REMARKS

II. Amendments to the Drawings

It is understood that previously submitted replacement drawings have not been entered in to the subject application. Accordingly, submitted herewith is a Replacement set of drawings, including FIGS. 1-5, which are to correct what appears to have been an inadvertent error in filing an incorrect set of drawings when the application was originally filed.

FIG. 1

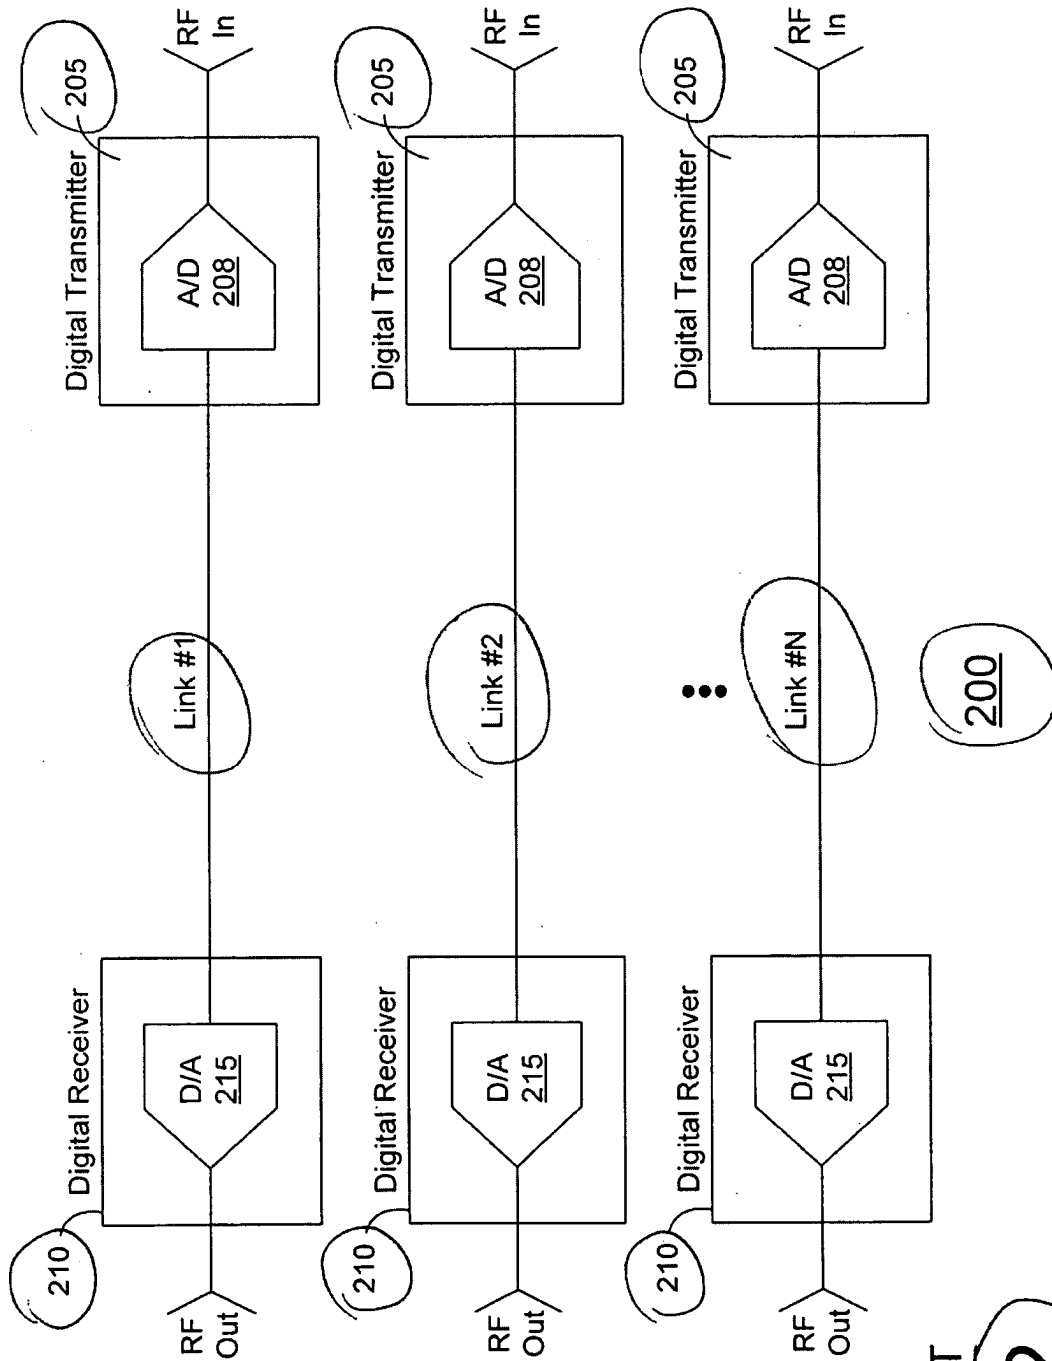
Amendments to Figure 1 are marked in red on sheet 1/6 of the attached Annotated Sheet of drawings. The amendments to FIG. 1 have been made so that the FIG. 1 accurately depicts what is described in the Specification at page 1, lines 16-30 by providing correct reference numbers in the drawings. The changes to FIG. 1 are fully supported in the Specification at page 1, lines 16-30, and no new matter has been added.

FIG. 2

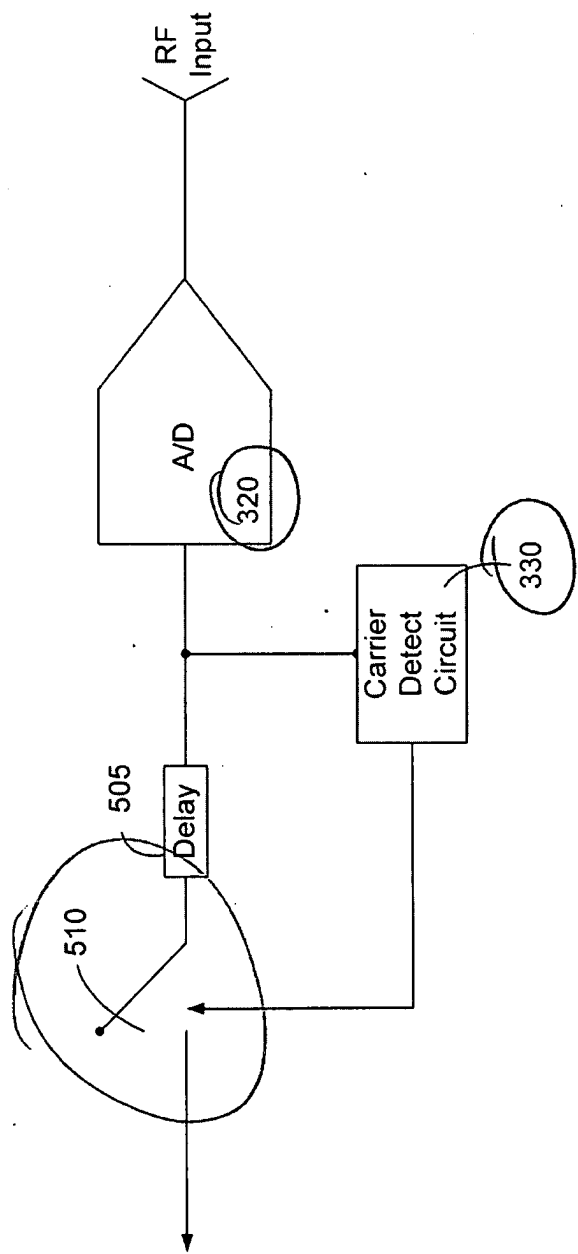
Replacement sheet 2/6 is being submitted to correct errors in originally filed FIG. 2. Amendments to Figure 2 are marked in red on sheet 2/6 of the attached Annotated Sheet of drawings. Originally filed FIG. 2 was submitted in this application in error, which is readily apparent upon inspecting the description of FIG. 2 in the originally filed specification. By this amendment is effectively being deleted from the application and being replaced by Replacement FIG. 2. The description of FIG. 2 in the specification beginning at page 2, line 5, describes what is depicted in originally filed Figure 3 (sheet 3/6), but originally filed FIG. 3 has its reference numbers increased by adding 100. Accordingly, the replacement sheet 2/5 for FIG. 2 is substantially identical to originally filed Figure 3, but has its reference numbers decreased by subtracting 100. Support for this Amendment can be found in originally filed FIG. 3 and in the Specification at page 2, lines 5-20. No new matter is being added by this amendment.
